A.R.M. (USA), INC 1506 Fernwood Rd. Wintersville, OH 43953 740.264.6599 740.266.2953 Fax Bulletin No: SA20170222 Release Date: Feb 22, 2017 Effective Date: Feb 22, 2017

SAFETY ALERT

Manufacturer: A.R.M. (USA), Inc. Ride Name: Super Shot

Model(s): SS1001, SS200, SS300

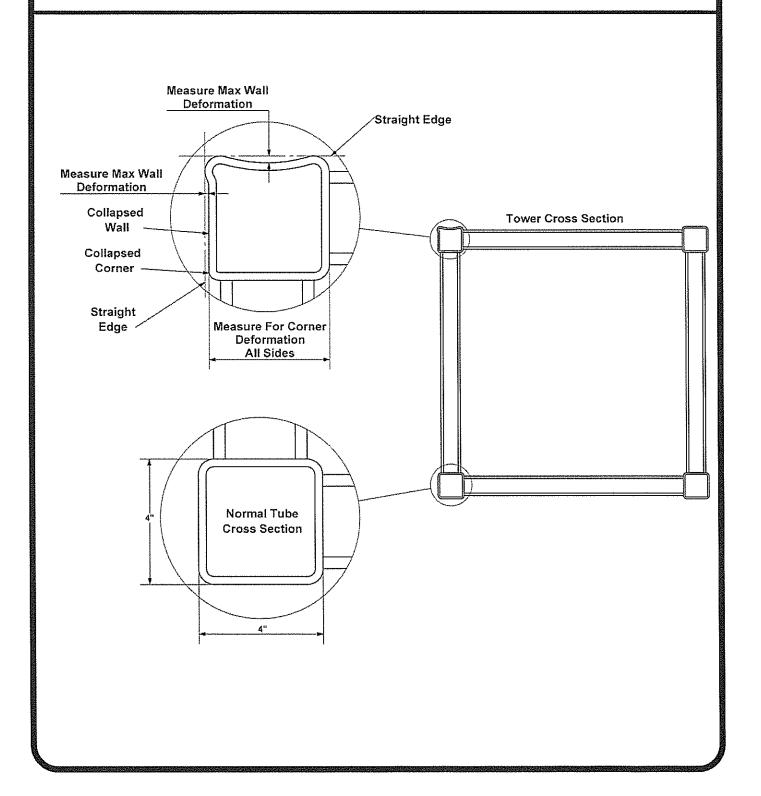
Immediate inspection of all tower structural tubes with emphasis on the four corner vertical tubes that the passenger carriage guide wheels contact. Any collapse of the tube walls or corners to be measured and reported to A.R.M. (USA), Inc. prior to continued operation.

Prior to continued operation, all tower corner tube members must be visually inspected for deformation, excessive wear, cracks or other damage. The depth of any collapsed portion of the tube members to be measured and reported to A.R.M. (USA), Inc. for review and possible repair advise.

Under no circumstances shall the ride operate with damaged tower tube members unless authorized, in writing, by A.R.M. (USA), Inc.
